Science Research and Education Facility

Australian Institute of Nanoscience
The University of Sydney

Section 96(1A) Modification (SSD 5087-2011)

July 2014

Figure 1 Type of Observatory Proposed

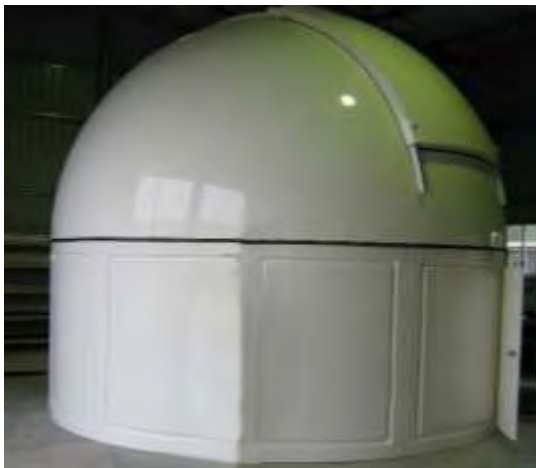
The University wishes to install a small astronomical observatory illustrated in **Figure 1**, on the roof of the AIN building for both teaching and research purposes. The observatory location is centred on the Wilkinson axis, and lower in height than the adjoining St Paul's development.

The general details of the proposed observatory are:

Total Height	4.5m
Wall height	1.8m
Diameter	5m
Door Size	1.37m
Aperture width	1.5m
Open Past Zenith	750mm

The observatory will house two telescopes currently owned by the University:

- Meade LX-200 30cm aperture; and
- a Newtonian 20cm aperture reflecting telescope (portable).
